**STAFF REVIEW AND RECOMMENDATIONS
PUBLIC HEARING
DECEMBER 7, 2016**

ABBREVIATED PLAT: **KOPPERUD FAIRHILL**
LEGAL DESCRIPTION: **SEC 08, T17N, R02E, SEWARD MERIDIAN, AK**
PETITIONERS: **LEIF KOPPERUD**
SURVEYOR/ENGINEER: **KEYSTONE SURVEYING/HOLLER ENGINEERING**
ACRES: 7.13 ± PARCELS: 2
REVIEWED BY: **AMY OTTO-BUCHANAN** CASE: 2016-161

REQUEST: The request is to create two lots from Tract 4, Kopperud Subdivision, Plat No. 2001-71, Section 08, Township 17 North, Range 21 East, SM AK, to be known as KOPPERUD FAIRHILL, containing 7.13+ acres. Proposed Lot 1 is .77 acres and will be served by City of Palmer water.

Kopperud Fairhills Subdivision
 Testhole, Useable Area, Drainage & Topography Map

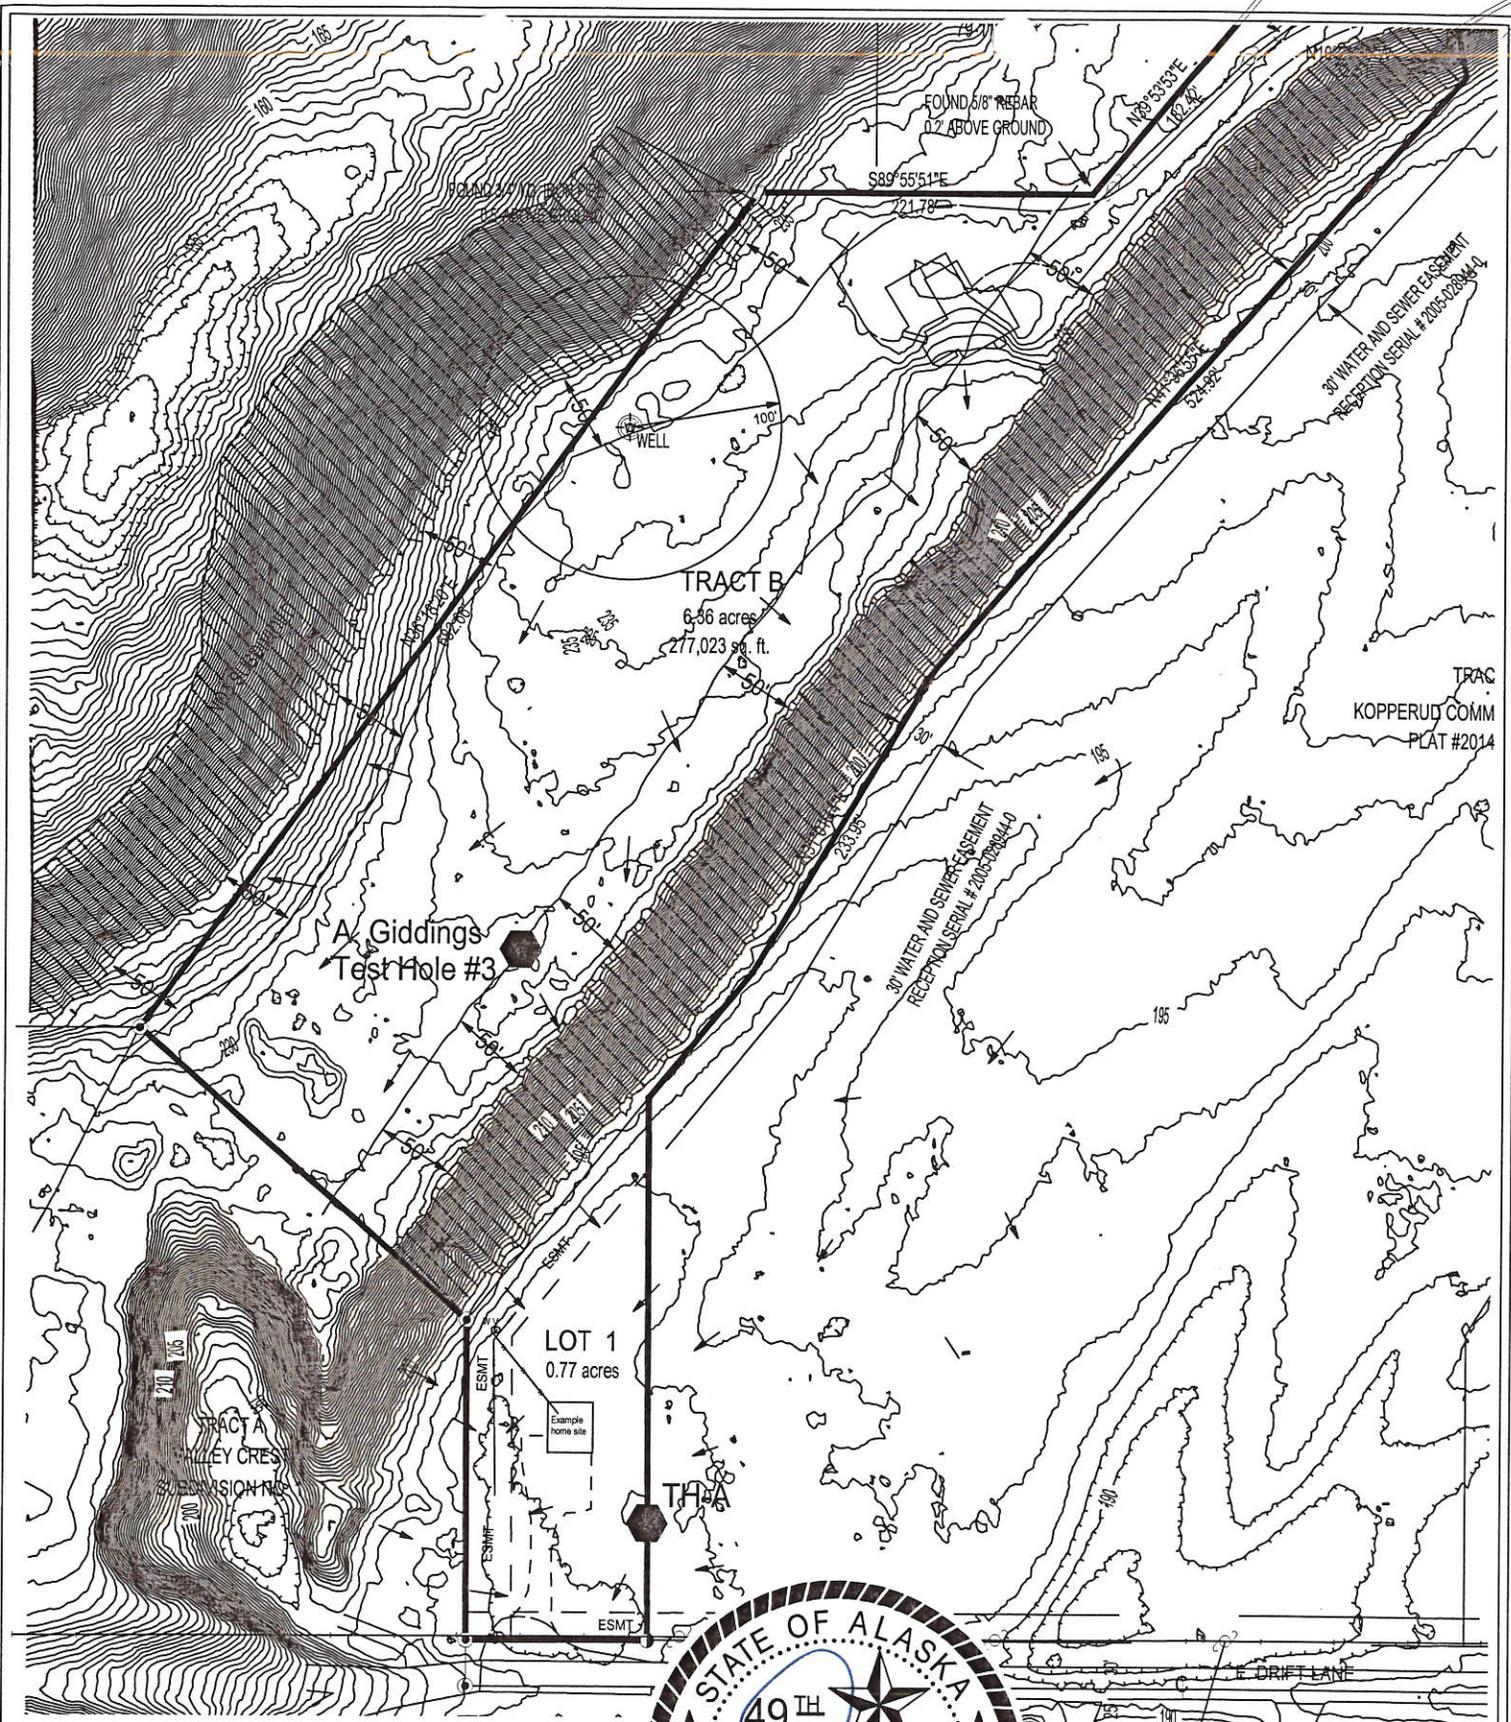
The petitioner also asked that I address a comment received from the City of Palmer Public Works reviewer, regarding being able to “maintain minimum ADEC sewer and water separation distance requirements if a building or house were to be constructed on this lot” as Lot 1 is a relatively small and bounded on 3 sides by an existing water main line. The lot already has an existing water line provision with a valve located near the northwest corner, so a water service line could be installed and no well would be necessary. Although there exists a water line and/or utility easements on the north, west and south side of the lot, a septic is only required to be outside of the easement and a minimum of 10’ from the water line. Installing a home and water service line would create new items to observe setbacks from (5’ and 10’, respectively). Despite all of the setbacks, the undeveloped lot will have approximately 21,000 ft² of useable septic area. A typical home and waterline development as shown on our sketch would reduce the useable septic area to around 18,000 ft², which is ample room for a large onsite system and several replacements, and is 180% of the requirement for a given lot.

Useable Areas. The proposed lots have a few limitations on areas defined by MSB code as *useable septic area* or *useable building area*. Useable septic areas will be limited by lotlines, setbacks to the top of the steep slopes, waterline easements and setbacks to an existing waterline bordering Lot 1 on three sides. For useable building area, limiting factors will be lotlines, utility easements, and ROW/PUE setbacks. Proposed lot 1 and Tract B contain adequate unencumbered area to meet the useable area requirements in their present configuration.

Based on the available soils & water table information, topography, MSB Title 43 Code definitions, and our observations at the site, ***proposed Lot 1 and Tract B will each contain over 10,000 square feet of contiguous useable septic area. Tract B will contain an additional 10,000 square feet of useable building area.***

**BIG LAKE, ALASKA
KORMAN
SUBDIVISION
AS-BUILT-PROPOSED SUBDIVISION**

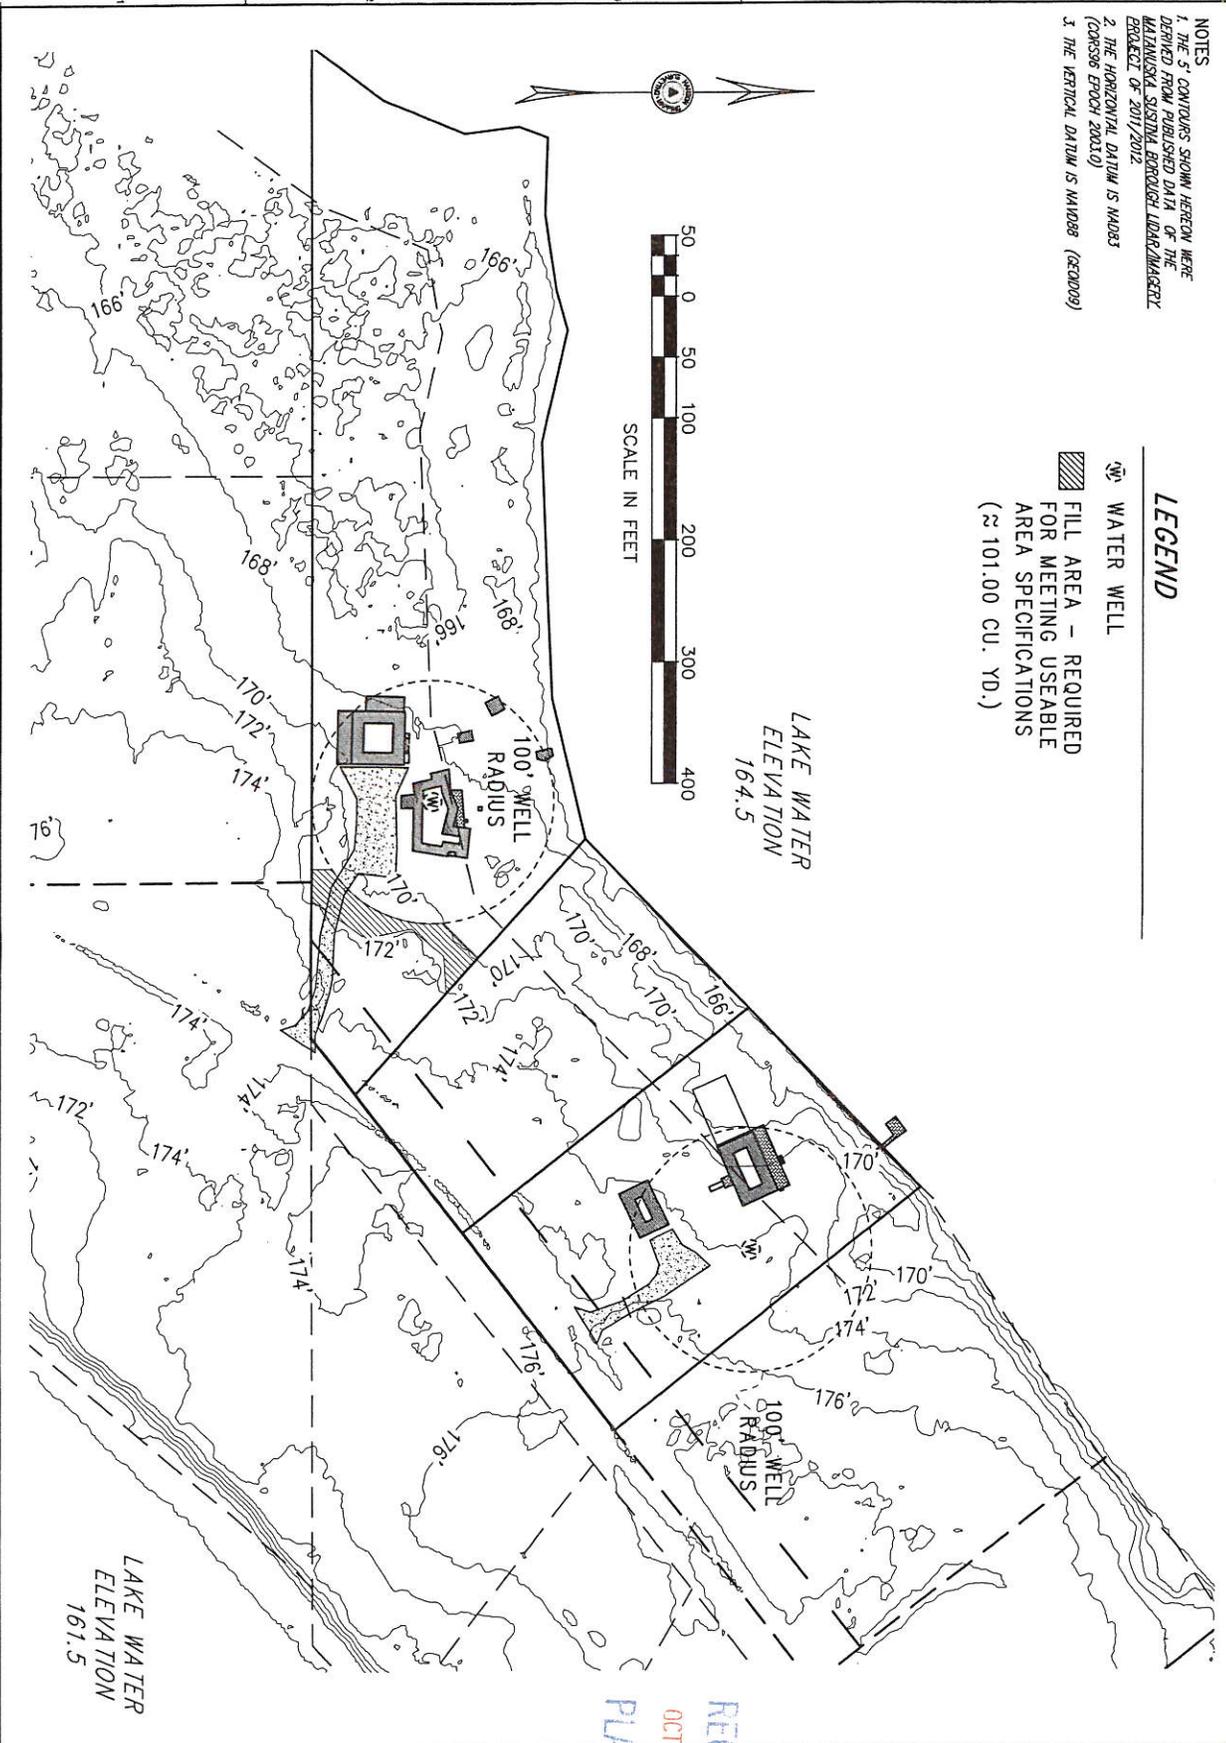
2 each have more than 10,000 sf suitable for septic in addition to more than 10,000 sf suitable for building. Proposed Lot 3 has more than 10,000 sf suitable for building; however, only 3,000 sf suitable for septic. An additional 7,000 sf of useable septic area is required for subdividing. This area may be created by placing fill so the new ground level is at least eight feet over the water table. Much of this area could be created by placing two feet or less of fill in the area around testhole #1. Any new useable septic area must be outside of the 100' well radius. The attached testhole location map shows approximate areas that are currently suitable for septic. A sieve analysis was performed on a sample of the soil at typical septic depth. The sieve test report is attached.

Staff notes an updated soils report from the engineer will be required (see **Recommendation #6**), once the fill on Lot 3 has been accomplished. The report will need to state that Lot 3 now has 10,000 sf of contiguous useable septic area. Staff notes the engineer has provided a sieve analysis report as required by MSB 43.20.281(A)(1)(f).
